ADDENDUM No. 1

RFP No. 23-11

Geddes Avenue and 2190 South State Street Retaining Walls

CITY OF ANN ARBOR - PUBLIC SERVICES - ENGINEERING
RETAINING WALL PLANS
GEDDES AVENUE RETAINING WALL
DETAILED GRADING PLAN - GEDDES AVENUE

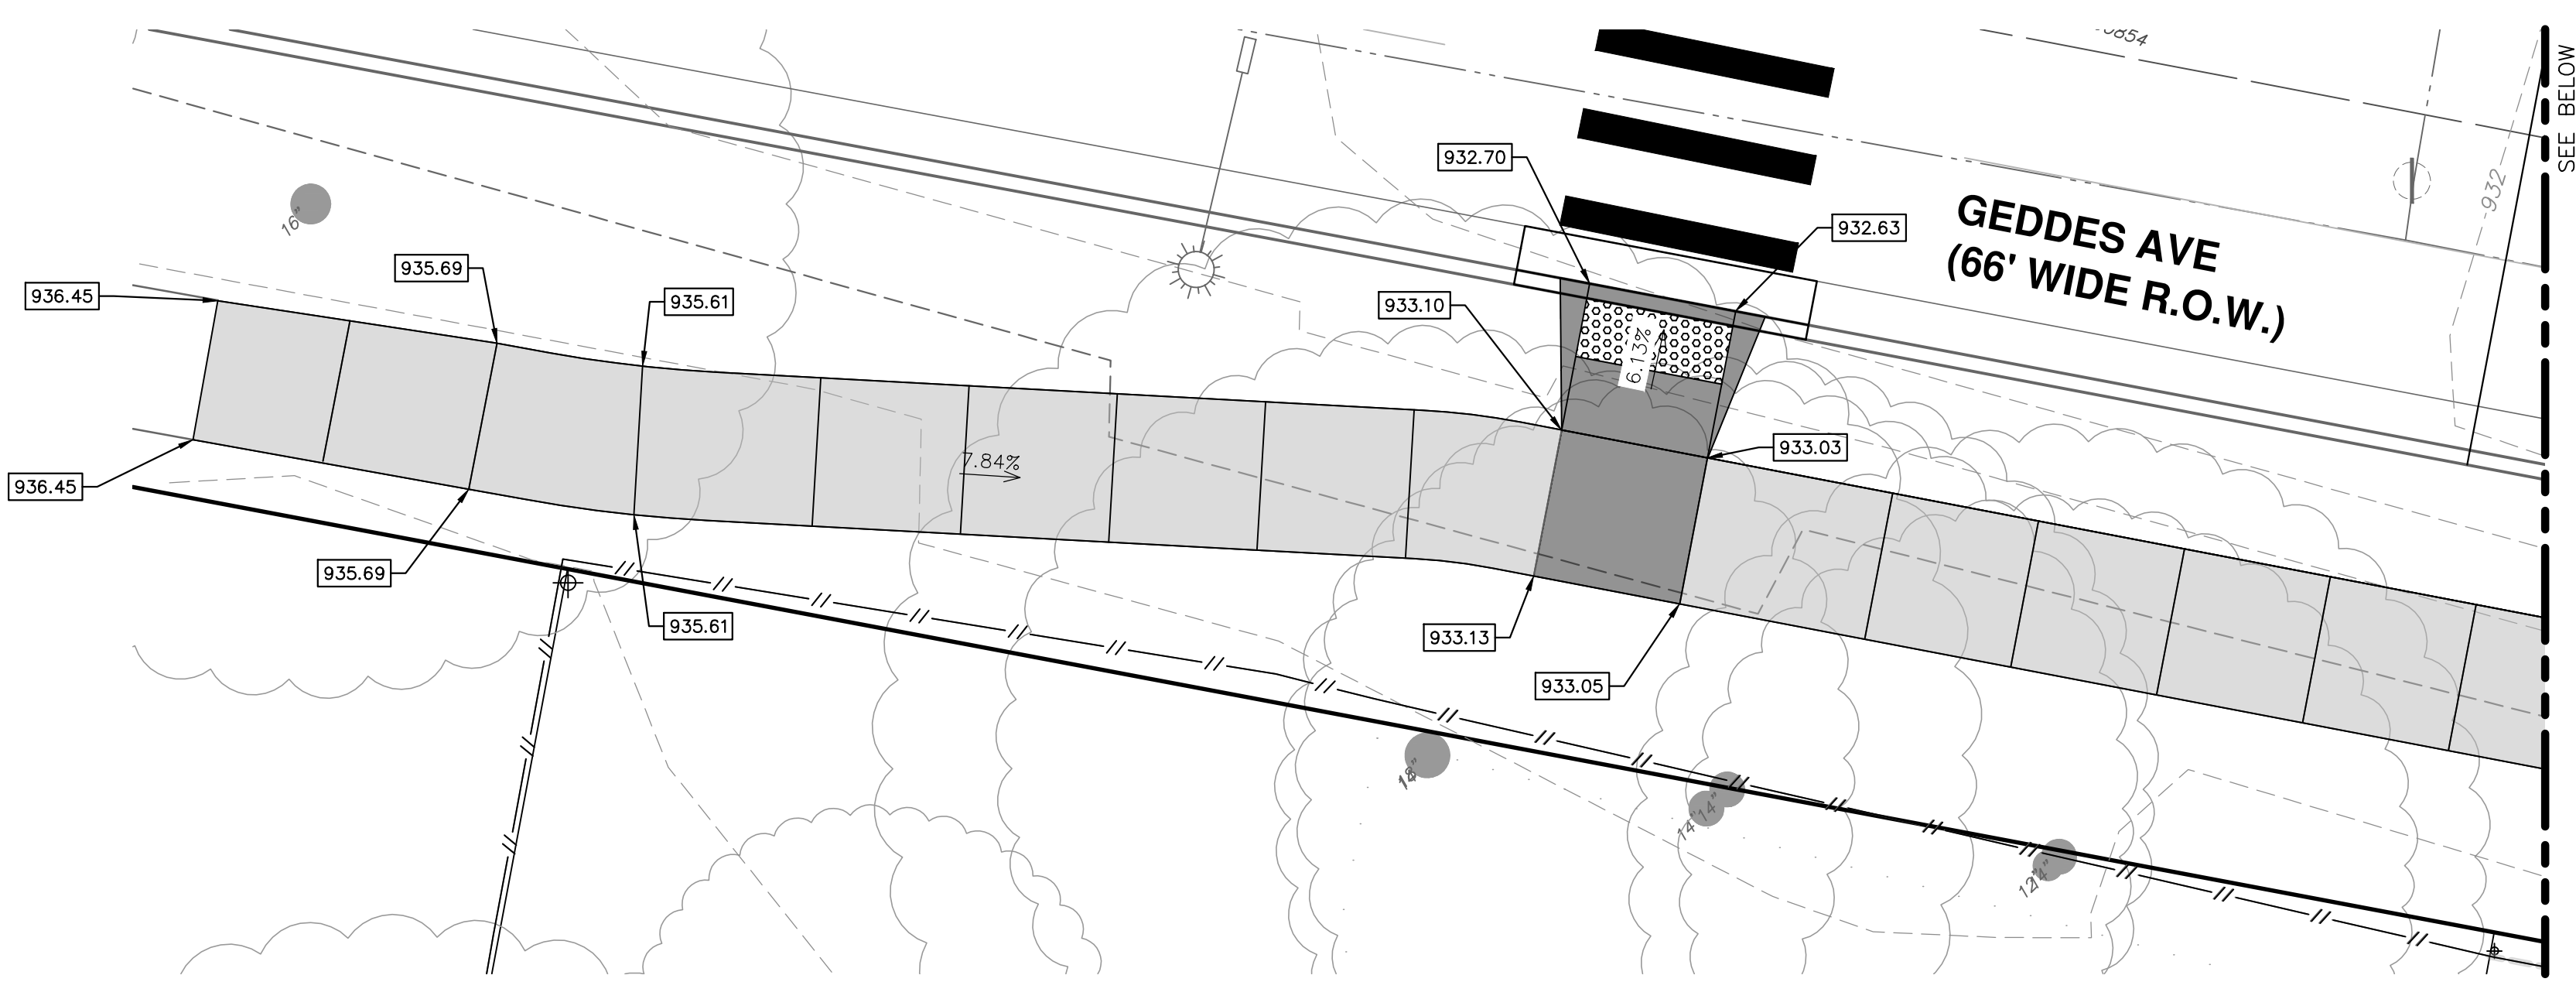
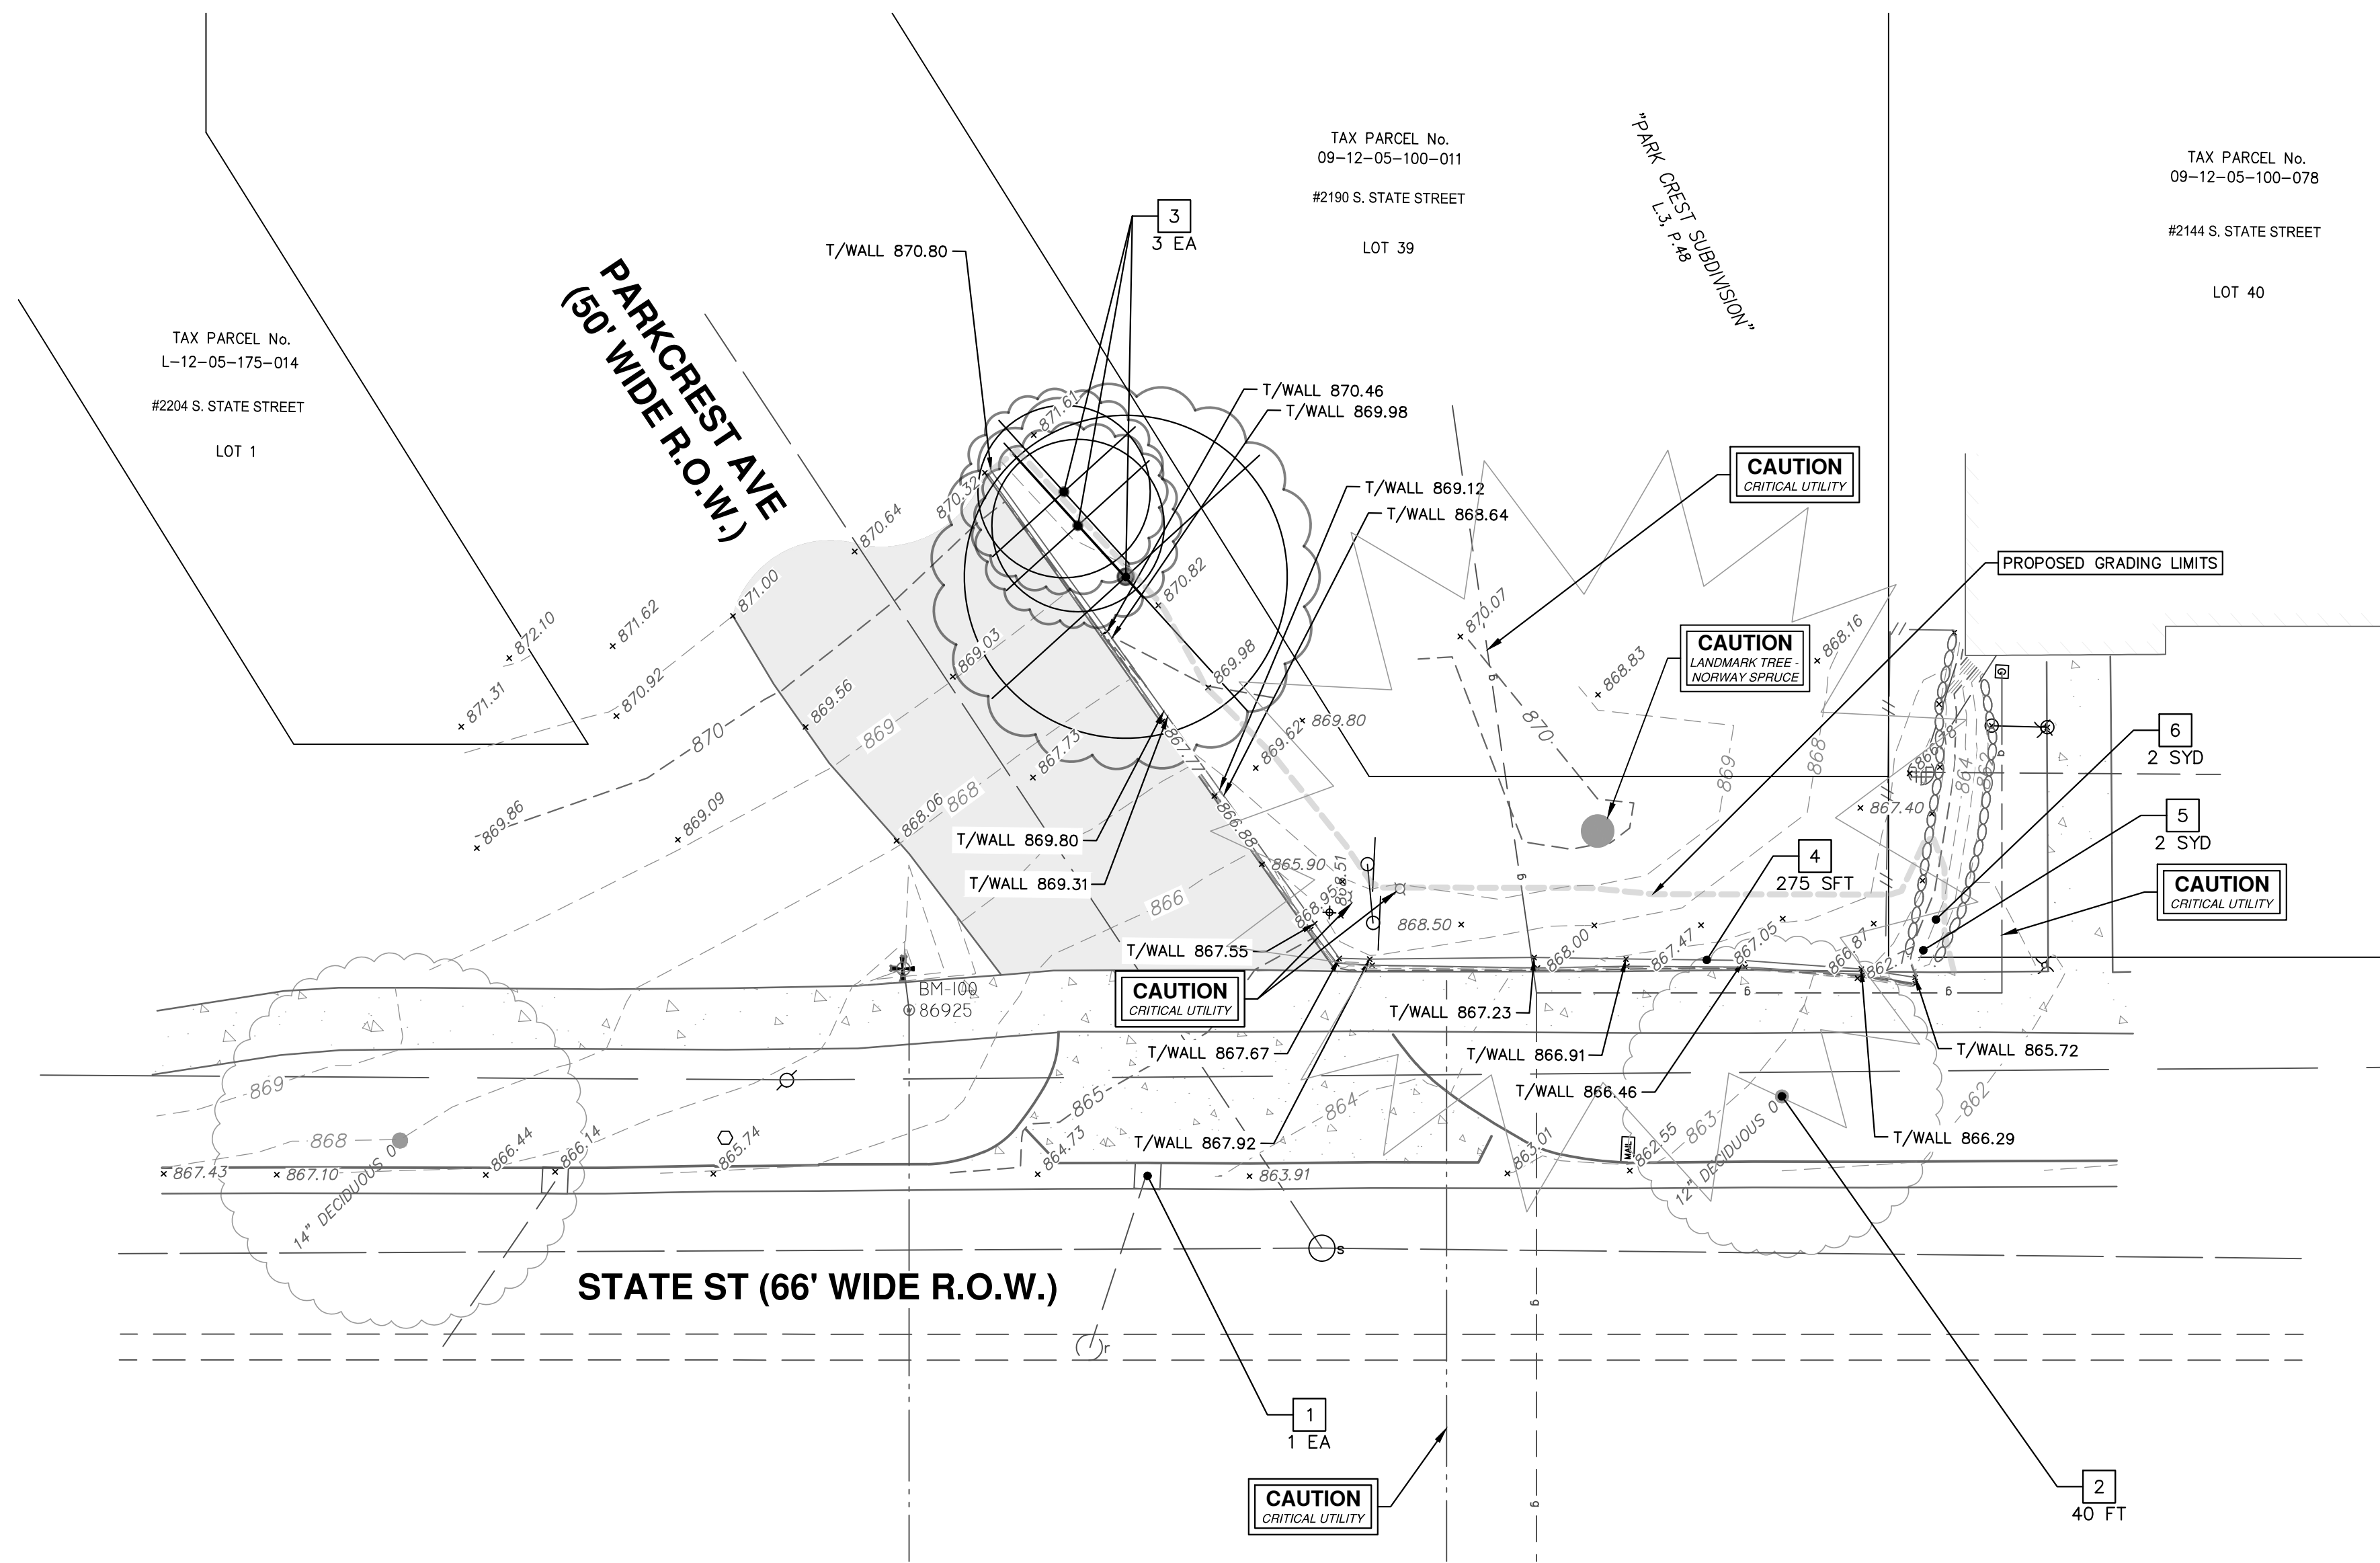
Sheet 6	Adjusted the grading and temporary construction easement limits and related call outs.
Sheet 7	Revised “Removal Key” items and descriptions to be consistent with contract pay items being used as part of the project. Adjusted the grading limits. Added and revised call outs including quantities related to removal work to reflect revisions to the “Removal Key”. Added notation related to the landmark tree and business signing and lighting on site

CONSTRUCTION PLAN - STATE STREET

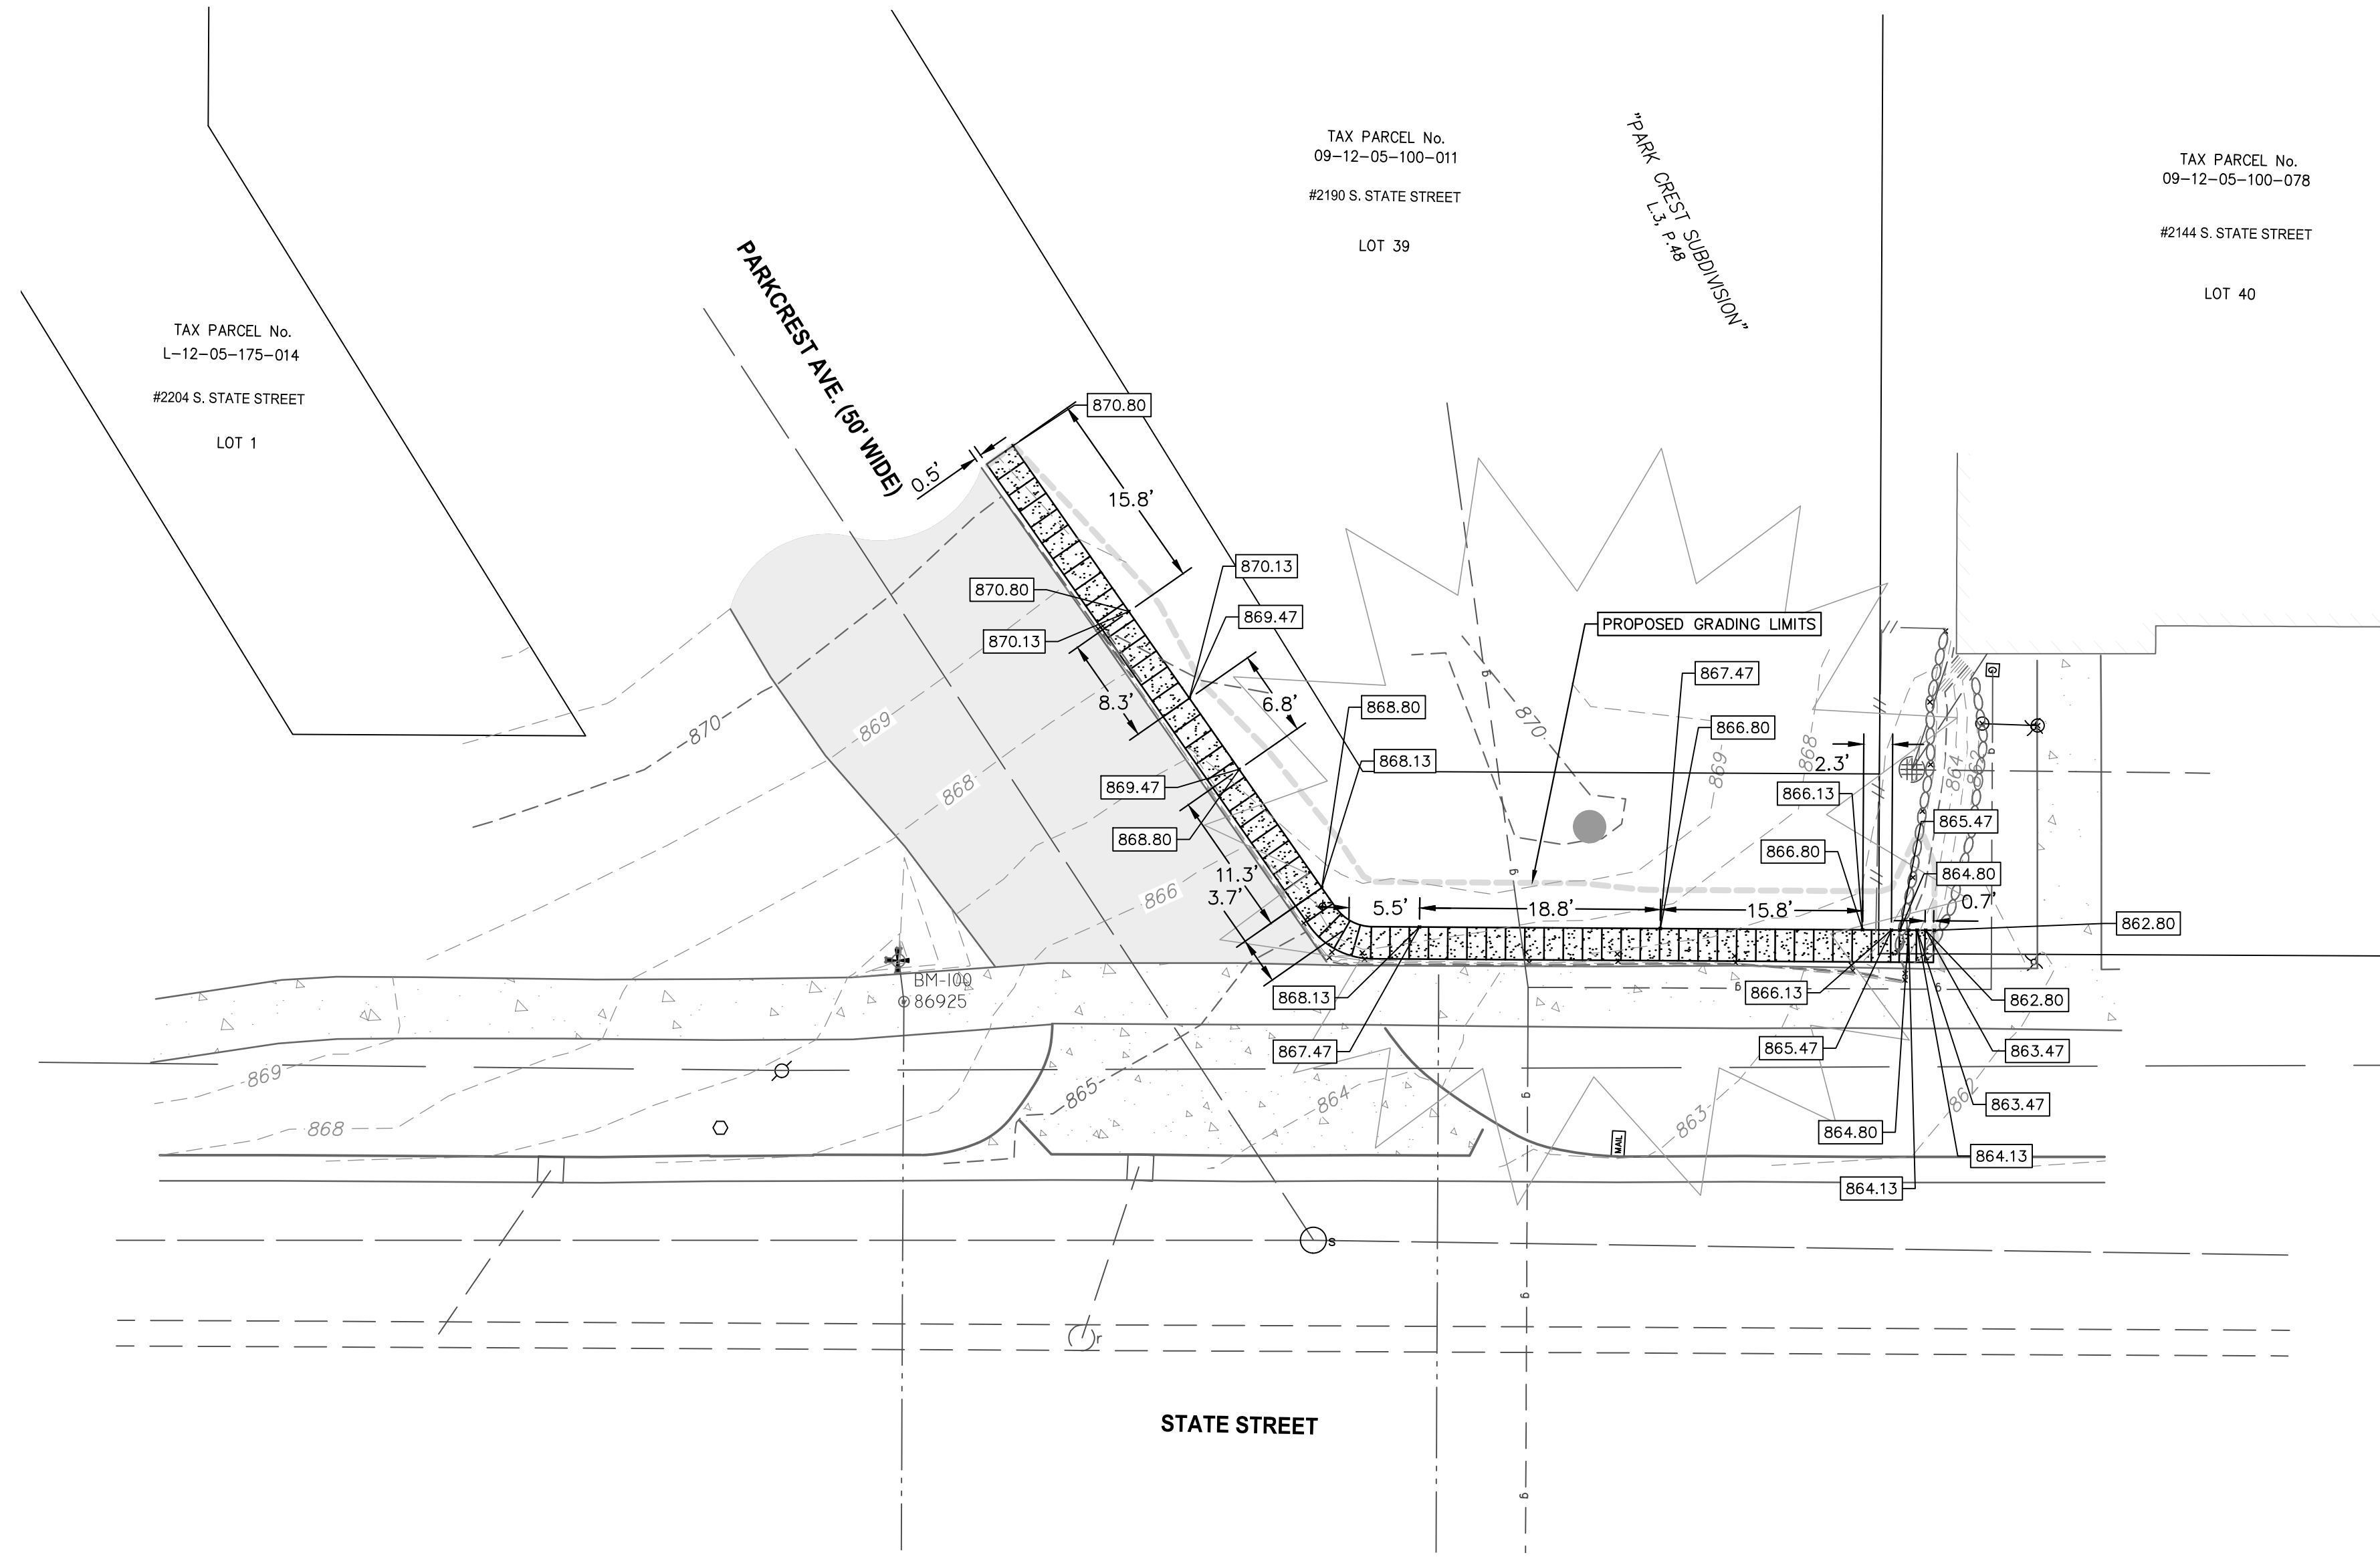
Sheet 8	Revised “Construction Key” items and descriptions to be consistent with contract pay items being used as part of the project. Adjusted the grading limits. Added and revised call outs including quantities related to construction work to reflect revisions to the “Construction Key”. Added notation related to the landmark tree and business signing and lighting on site
